## Planning Commission Staff Report

**SUBJECT:** UP13-04, GILBERT TOWN CENTER APARTMENTS: REQUEST TO APPROVE A CONDITIONAL USE PERMIT FOR APPROXIMATELY 13.72 ACRES OF REAL PROPERTY LOCATED SOUTH AND EAST OF THE SOUTHEAST CORNER OF GILBERT ROAD AND WARNER ROAD TO ALLOW A MULTI-FAMILY RESIDENTIAL USE IN THE REGIONAL COMMERCIAL (RC) ZONING DISTRICT WITH A PLANNED AREA DEVELOPMENT (PAD) OVERLAY.

**A1.10**

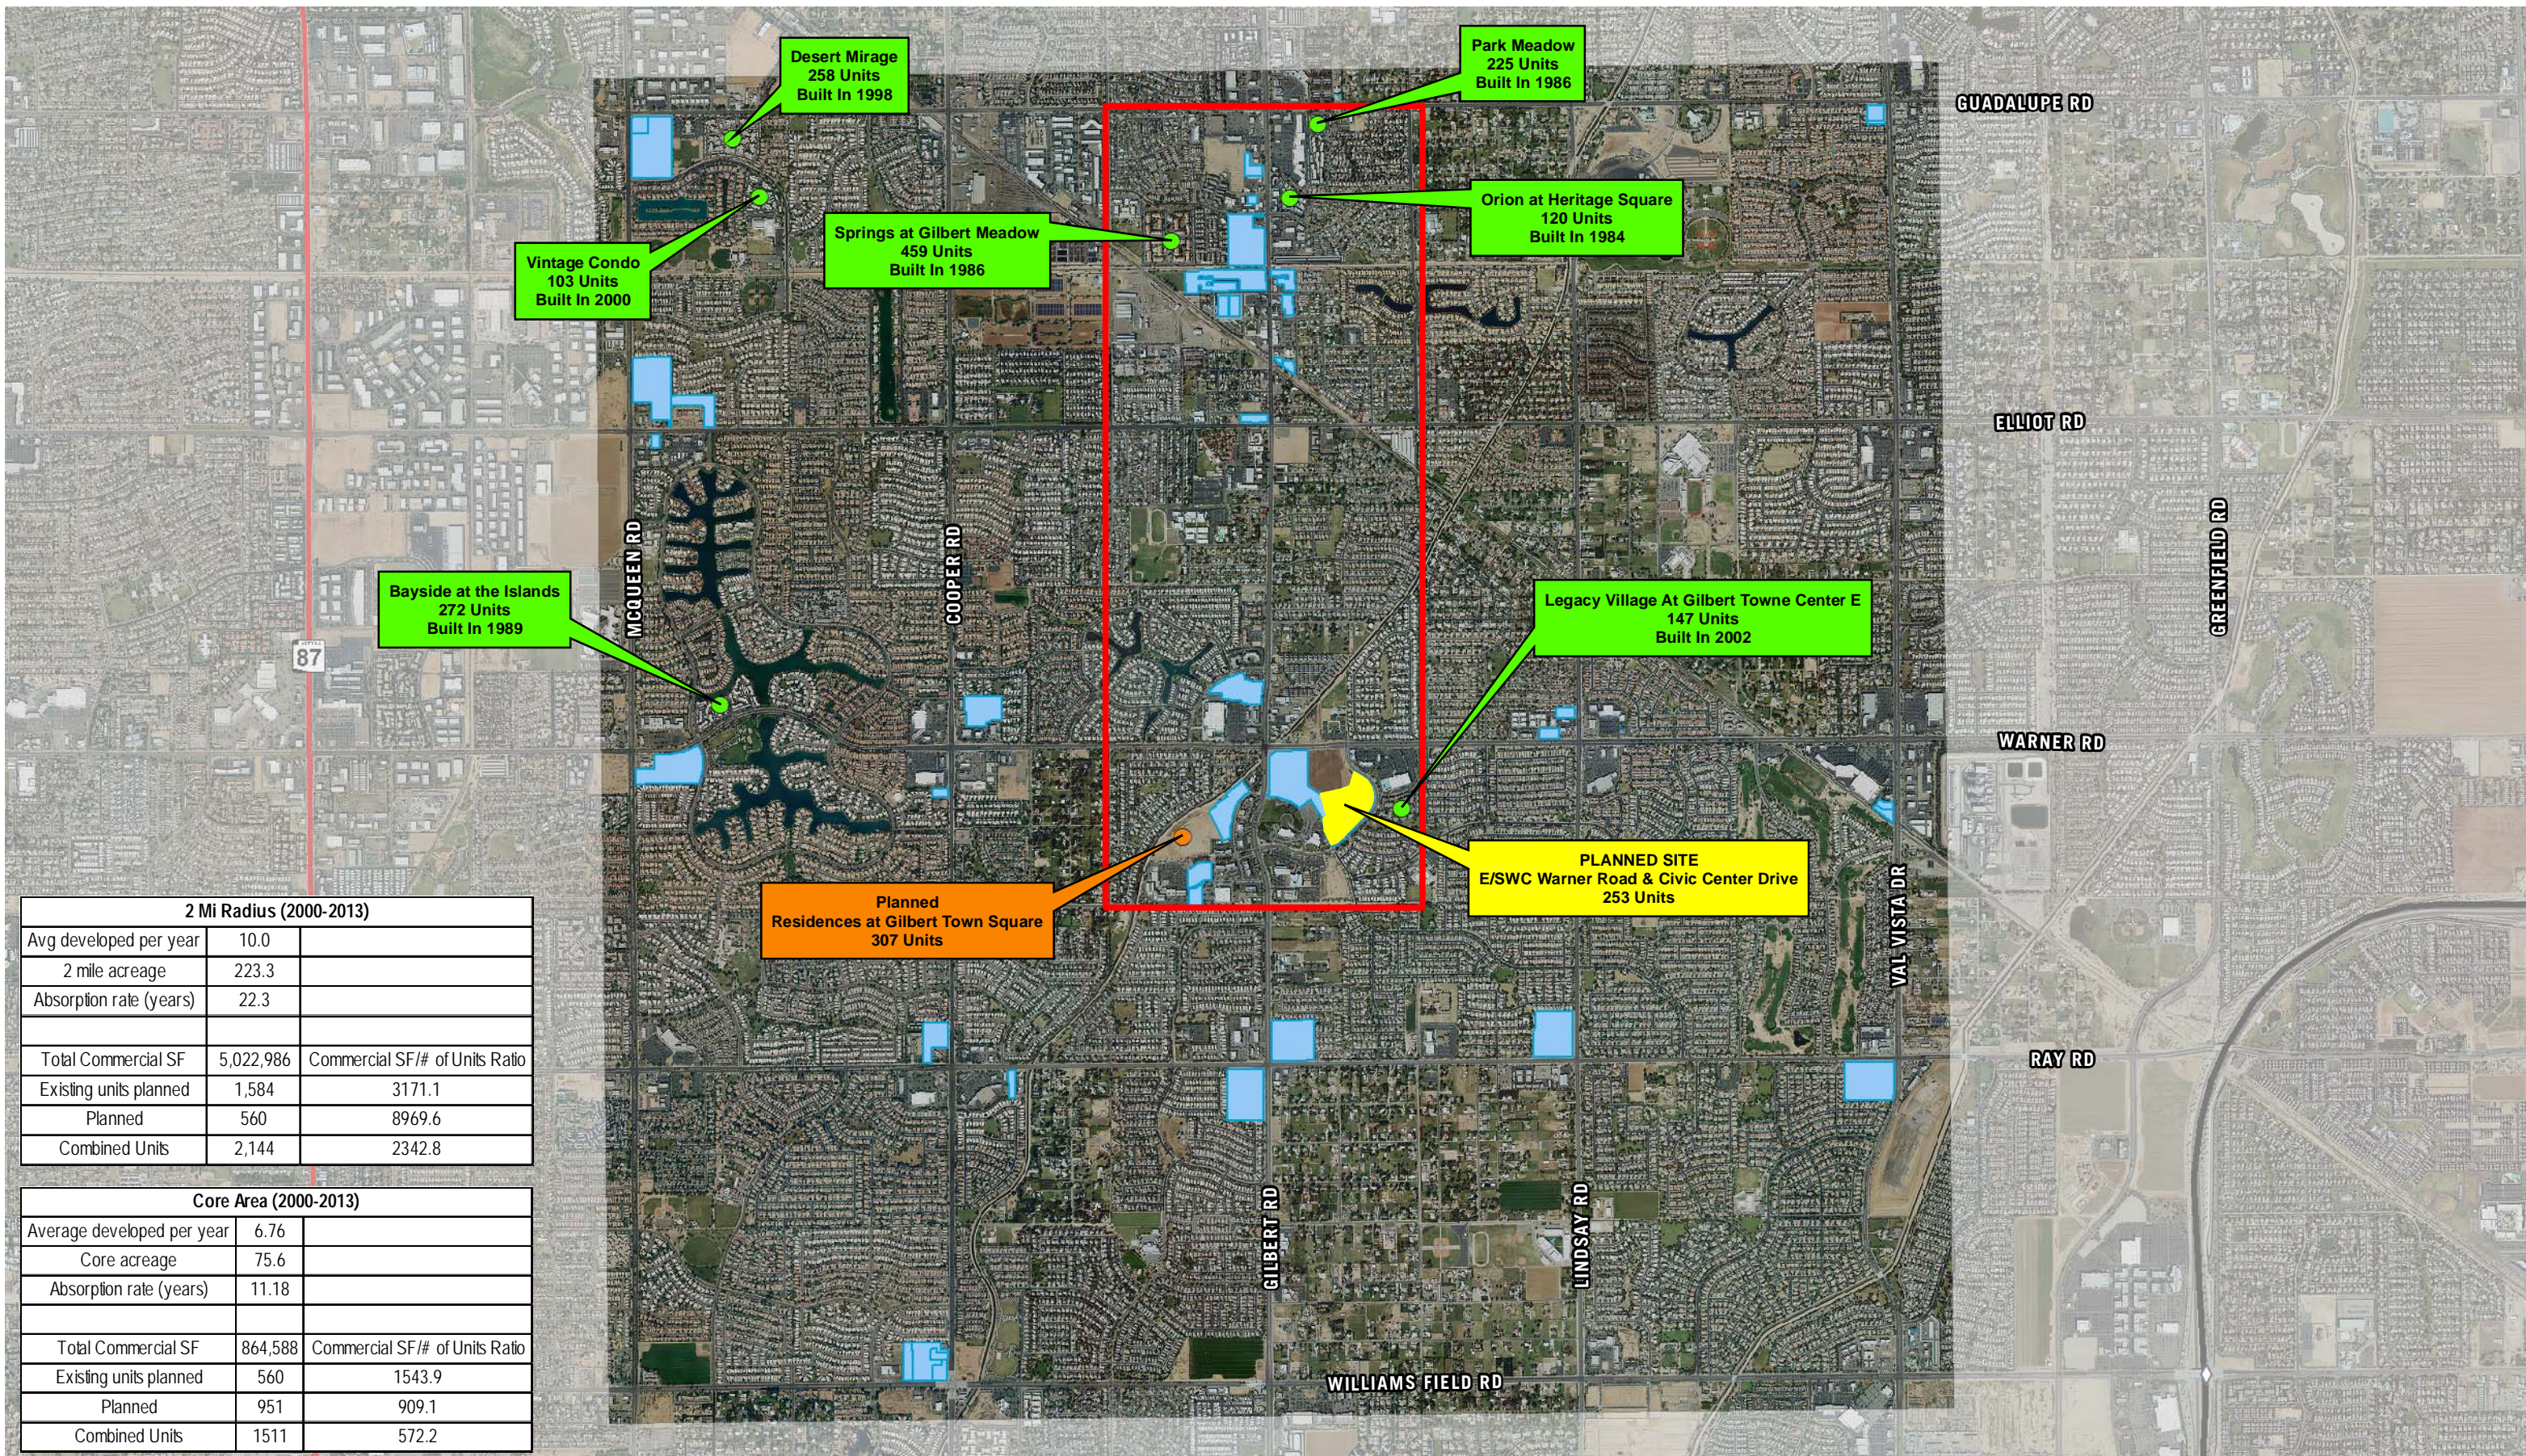
*Staff believes that the proposed development plan does not provide for either vertical or horizontal integration and therefore does not comply with the intent of this finding of fact, as the proposal does not provide for an efficient design that cultivates the intended sense of a live, work, and play environment but rather relies on a stand-alone suburban multi-family apartment complex design. Additionally, there would be the loss of 13.72 acres of commercial uses without the benefit of creating a more regional draw at one of the most significant corners in the Town of Gilbert.*

*Staff finds that the proposed development plan provides a layout and design that relies predominantly upon automobiles for ingress and egress of the subject site and provides for a standard, stand-alone apartment complex design and does not meet demonstrate sustainability through compact design. The applicant has proposed a 6’ wide decomposed granite pathway “fitness trail” which is essentially the sole method of integration and outdoor gathering area between the proposed multi-family parcel and the remainder of the overall 37 acre site. This is the feature that the applicant believes complies with the use permit findings of fact related to compact design and pedestrian scale and orientation. A*

*Staff believes that the proposed development plan exhibits does not provide for or meet the intent of this design requirement. The proposed development plan essentially creates a stand-alone multi-family development, predominately isolated from the remainder of the overall Gilbert Town Center site. The applicant has proposed a 6' wide decomposed granite pathway in order to connect the municipal complex to the north between the Banner Health Center parcel and the proposed multi-family parcel as essentially the sole method of integration between the proposed multi-family parcel and the remainder of the overall 37 acre site.*

*The proposed project has not demonstrated appropriate vehicular and pedestrian connectivity that serves vehicles, pedestrians and bicycles. Staff notes that when the 13 acre Banner Health Center site was rezoned in May of 2012 under Ordinance No. 2368, the original intent was for Banner in coordination with the proposed multi-family parcel/ southeast parcel (Parcel 2) to develop and improve a drive aisle between the two parcels and provide a secondary vehicular connection between Palm Street and Civic Center Drive. This was the reason for creating the Banner Health Center parcel shape as it is and the remaining southeast parcel (Parcel 2). The proposal under Z13-08 no longer provides for this access drive and staff believes this further detracts from the connectivity of the site as there will now be no north-south vehicular connection until such time as the northwestern (Parcel 1) develops, which will not help with the traffic impact of the proposed multi-family use on the southwest parcel (Parcel 2).*

Staff notes that the applicant has not made substantive changes to the design of either Z13-08 or UP13-04, with the exception of the applicant noting they were looking into fencing changes along the site perimeter. Planning staff continues to not be supportive of the requests under Z13-08 and UP13-04.
